Based on the above findings of fact, the proposed project satisfies the applicable criteria and staff approves the Partition Application No. PA 24-04, Woods Partition #2, pursuant to the conditions of approval listed below.

TENTATIVE PARTITION PLAT
 FOR
GARY WOOD
 LOCATED IN THE
 NE 1/4 SEC. 20 T. 10 S., R. 3 W., W.M.
 CITY OF MILLERSBURG, LINN COUNTY, OREGON
 OCTOBER 18, 2024

TO: Matt Straite, City Planner
FROM: Andrew Potts, Millersburg City Engineer
DATE: October 25, 2024
SUBJECT: PA 24-04 - Engineering Comments

SUBJECT: PA-24-04 –NE Woods Rd - Residential Partition – Fire Department Comments

PA 24-04 Vicinity

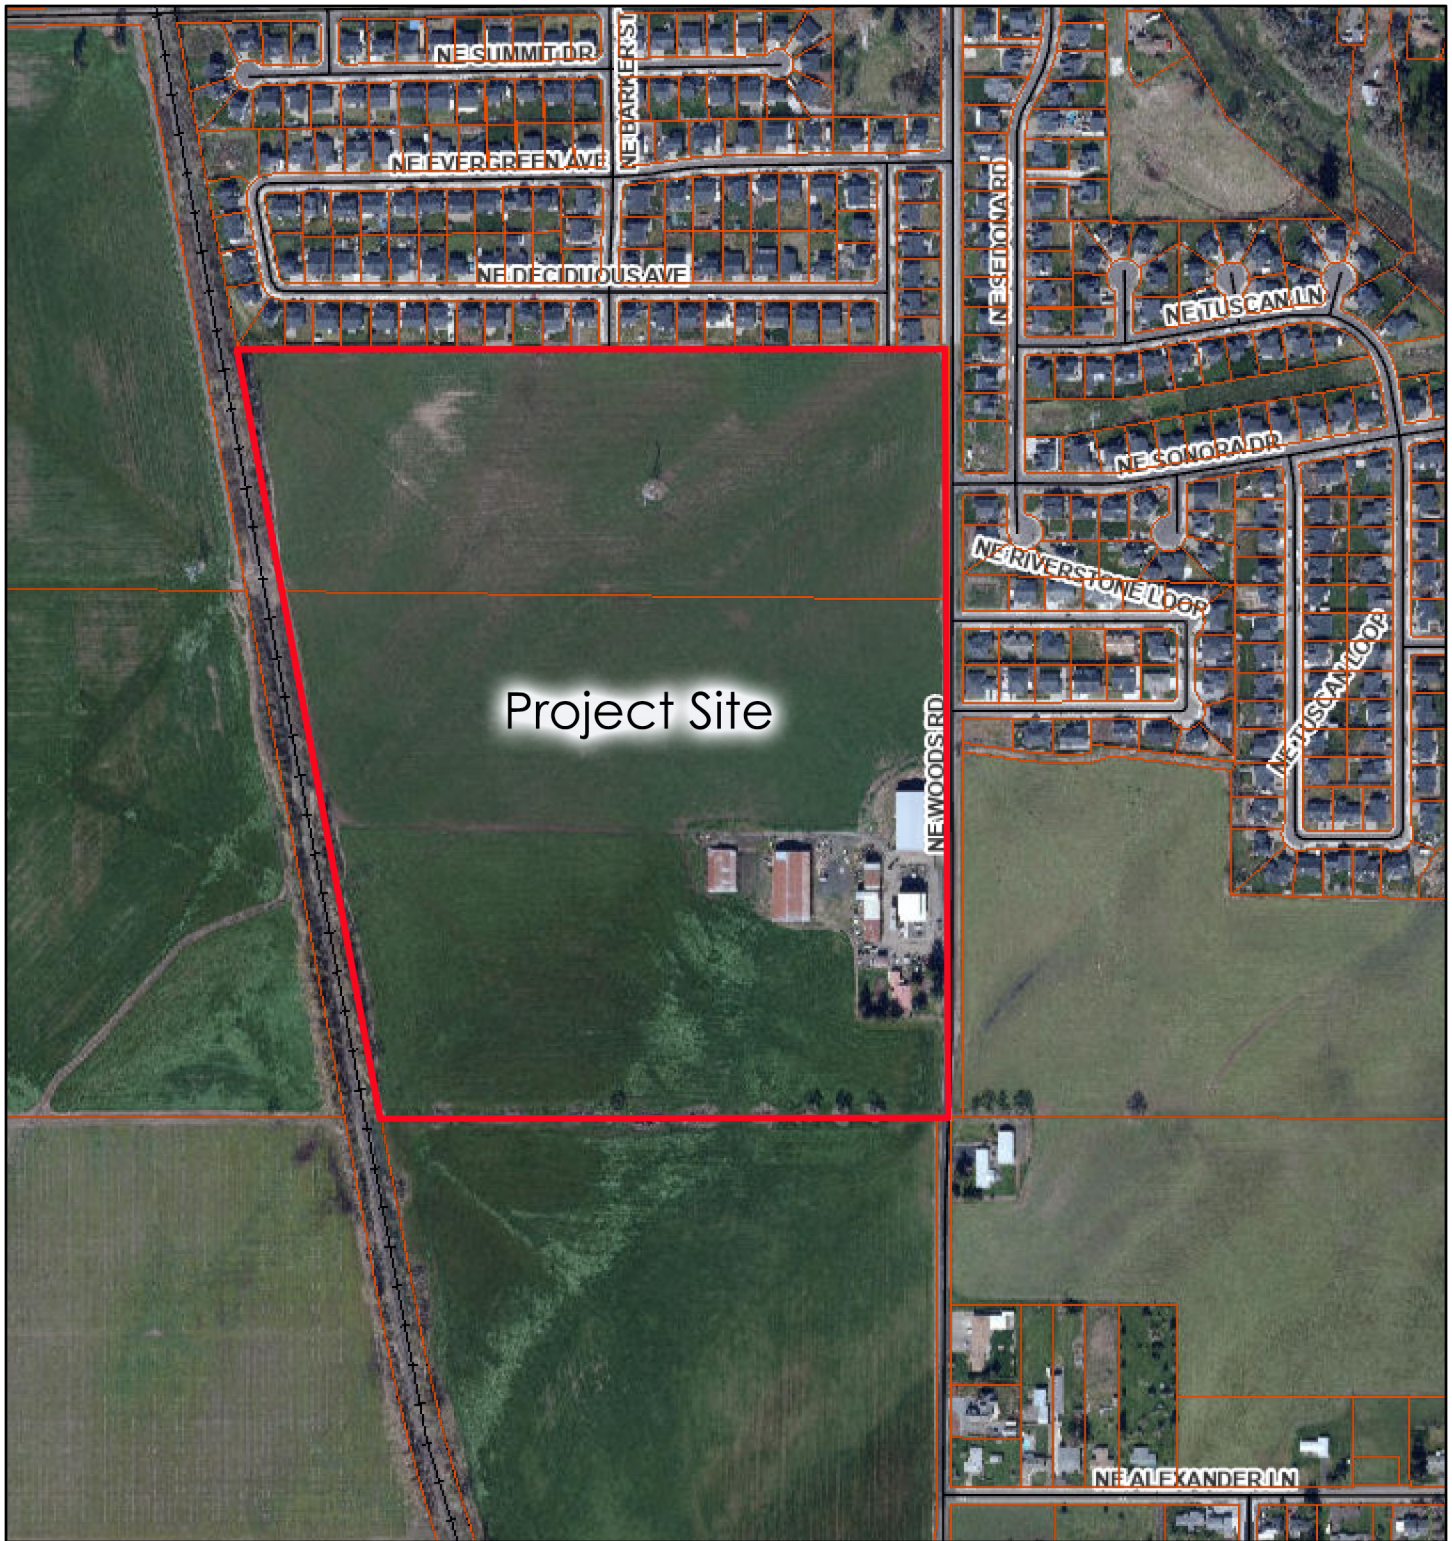
I live in Woods Estates, and my house backs up to the PA 24-04 Vicinity Project Site. I live on Deciduous Ave. This project site is literally in my back yard. I have read the exhibits and links provided and I realize that the family states that they are only doing this for "estate planning", but I fear this is just a door into developing this property into more housing. I chose my house location 6 years ago because I loved the view of the farm field and not having any neighbors in my back yard. I am very concerned about this partition of property, and do not support this land being parcelled out.

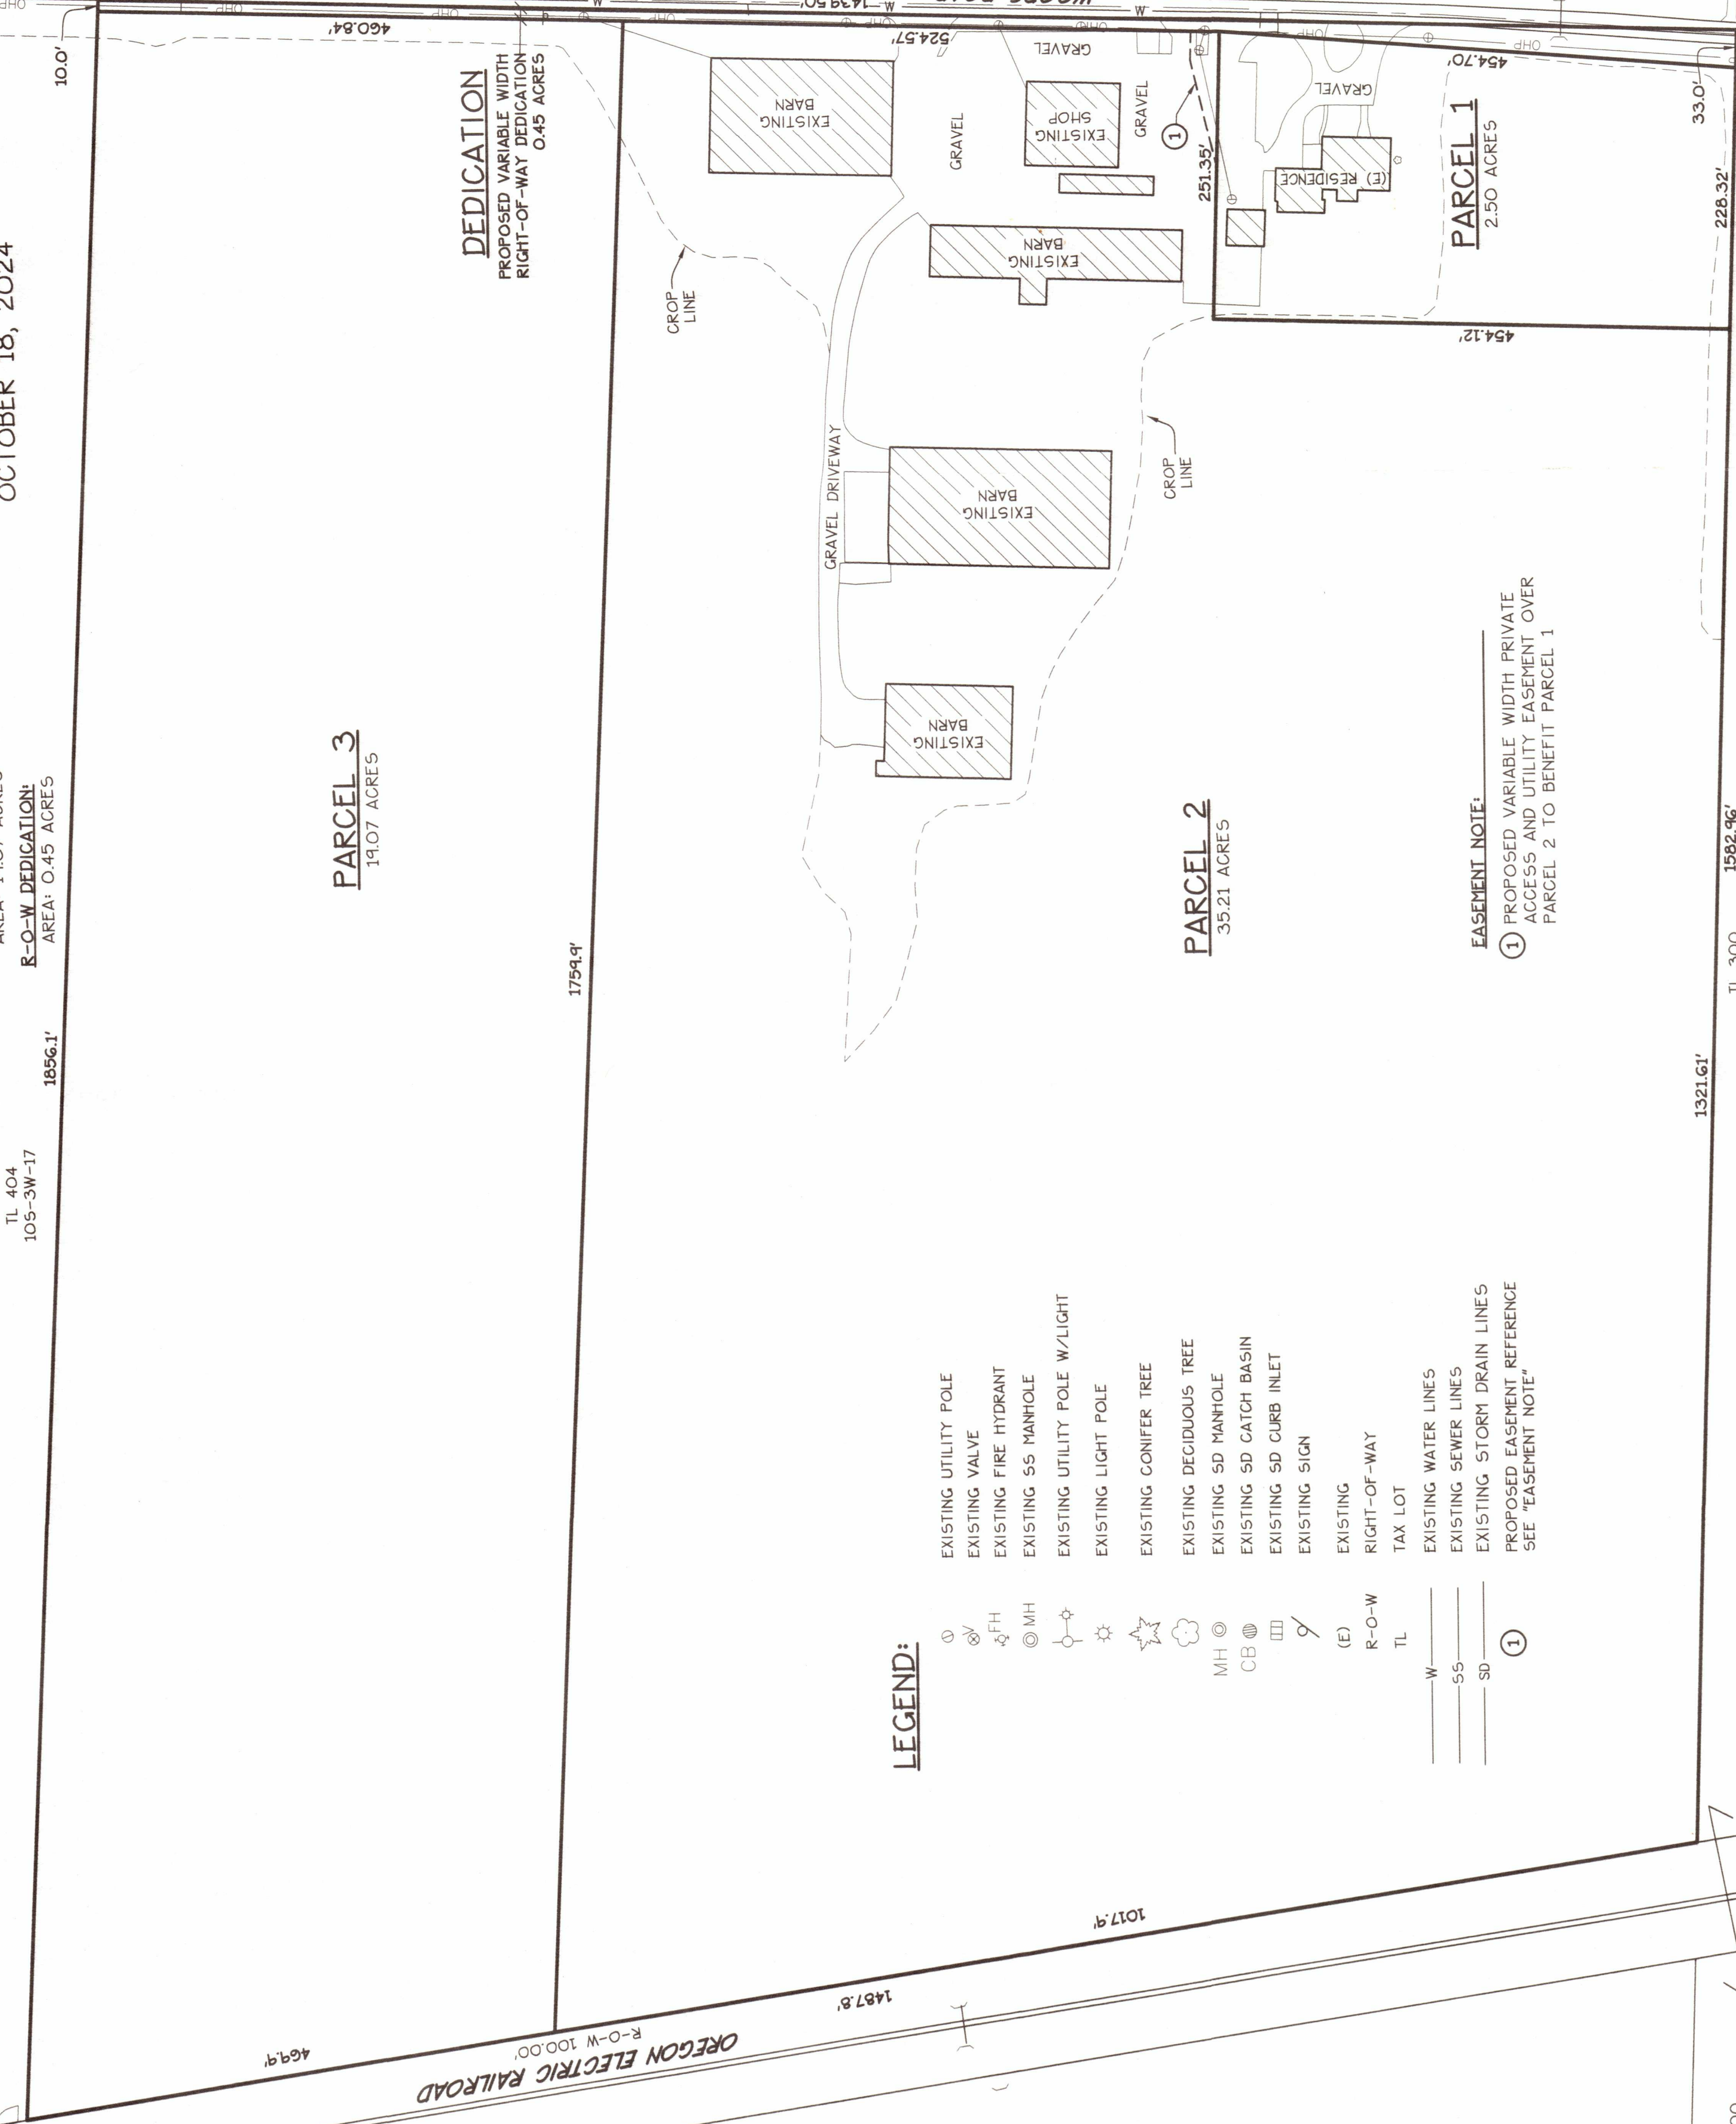
ANALYSIS: The RU setbacks are 20 feet to the front, 20 feet to the rear and 15 feet on each side. Proposed parcel 1 contains two structures, one single-family home with attached garage, and one shop. The single-family home structure meets all setbacks with the new proposed property lines. The detached shop meets the setback requirements for accessory structures as regulated by Section 3.15, Table 17 of the Development Code, which requires an 8-foot setback for a two-story structure. As shown the accessory structure (shop) is 10 feet from the proposed property line.

Proposed parcel 2 contains six (6) structures. These are all agricultural structures, there does not appear to be a primary structure, making it difficult to identify which structures are primary and which are accessory structures. All structures meet the higher standard of setbacks for a primary structure, therefore this proposed parcel complies with all setbacks.

ANALYSIS: The project proposes three parcels. All meet the minimum lot area required, which is 2.5 acres based on the RU Zone. The width to depth ratio, as stated in the Code, is 3:1, meaning the width cannot be more than 3 times the depth (or vice versa).

- For parcel 1 the width is 454.12 feet and the depth is 228.32 feet. This is under the 3:1 ratio.
- For parcel 2, the width is 1017.9 feet, and the depth averages about 1500 feet. This is under the 3:1 ratio.

- For parcel 3 the width is 469.9 feet and the depth averages about 1808 feet. This is more than the required width to depth ratio and does not comply. However, the intent of this requirement is to assure that a smaller single family lot is not designed in a way that could prevent future divisions. For example, if a 20,000-square-foot lot were designed to be so long and skinny that it could not eventually be two 10,000-square-foot lots, that would be a situation that this requirement was designed to prevent. A 19-acre lot with over 400 feet of frontage can easily divide again into a full subdivision even with a width to depth ratio of greater than 3:1. The two existing divisions to the north of this site are examples of how this 19 acres could develop in the future. For this reason, this standard does not apply to this proposed lot.

1. Approved fire apparatus roadways must extend to within 150 feet of all exterior portions of any structure that will be built on the new created lot as measured by an approved route of travel around the exterior of the structure with dead-end lengths not exceeding 150 feet long unless an approved turnaround is provided. (OFC 503.1.1, OFC 503.2.5 and OFC, Appendix D 103.4).

2. The fire apparatus roadways for this project accessing the site from the public way and serving two or more residential structures are required to be provided and maintained with a minimum 20 feet wide improved surface. (OFC 503.2.1)

3. Dead-end fire apparatus roads in excess of 150 feet in length shall be provided with an approved area for turning around fire apparatus (OFC 503.2.5 and D103.4)

1. Development and/or the design of the final partition plat shall conform substantially to the tentative partition development plans submitted by the applicant dated October 18, 2024, and attached to this staff report, except as modified in the conditions below, and shall conform specifically to final construction plans reviewed and approved by the City Engineer and the Building Official (Linn County) if required. All plans shall comply with the applicable building, planning, engineering, and fire protection codes of the City of Millersburg.
2. **This approval is valid for a period of one (1) year from the date of the decision notice.** Extensions may be granted by the City as afforded by the Millersburg Development Code.
3. Wetlands may be present on the site. Work within wetlands is subject to the requirements of the Authority Having Jurisdiction (AHJ).

4. The Final Plat shall be submitted for review by City staff prior to recording said plat with the County. The plat shall be drawn by a licensed land surveyor.
5. Prior to City approval of the final plat, the applicant shall provide evidence to the City that all requirements shown in the Albany Fire letter dated October 25, 2024, have been met.
